Project Plan 9-94004

STAFF REPORT

CLARKSBURG TOWN CENTER

March 22, 1995

FIGURE 19

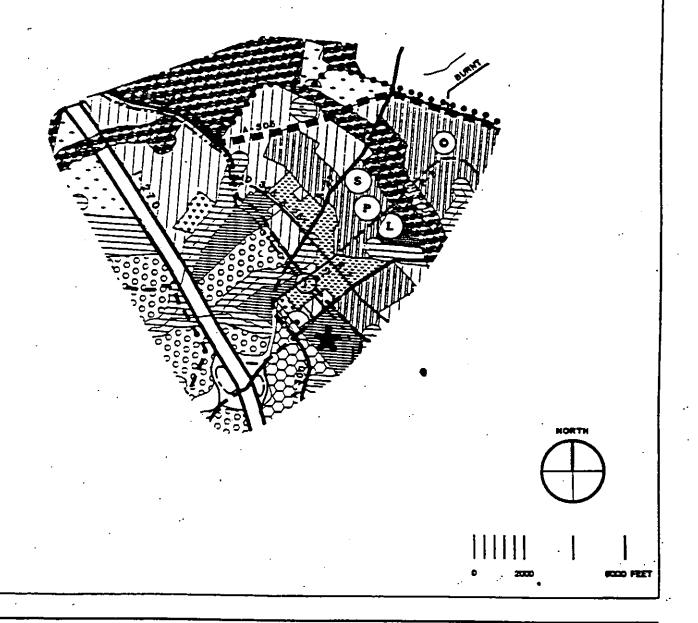
- A. Submit for review prior to Planning Board hearing on the reliminary plan submission:
- Improved plans for stormwater management (SWM) and grading in the commercial area that reduce stream buffer encroachment. As part of this, submit an alternative plan for review that shows all road grading, SWM and associated grading entirely outside of the stream buffer, to evaluate the impacts on site design and SWM effectiveness. Also submit calculations for the proposed instream dry pond on the commercial side showing the frequency and extent of inundation in the ponding area.

- Plan for the proposed SWM facilities and roads near or in stream buffer, and associated grading, with indication of where tree planting is permitted.

- 3. A staging plan for SWM with the extent of each proposed phase of development and the order in which they will be built.
- A preliminary forest conservation plan reflecting the revised layout. At the first site plan review, applicant should present reforestation/afforestation plans for the whole site and plant as much as possible during the first construction phase to meet a Special Protection Area recommendation for quickly establishing forest.

- 5. Landscaping plan for SWM areas at site plan.
- B. Modify plan as follows:
- 1. Move these stormwater management facilities, and any associated grading that cannot be reforested, outside of the stream buffer. Make every effort to reduce or eliminate all grading from buffer:
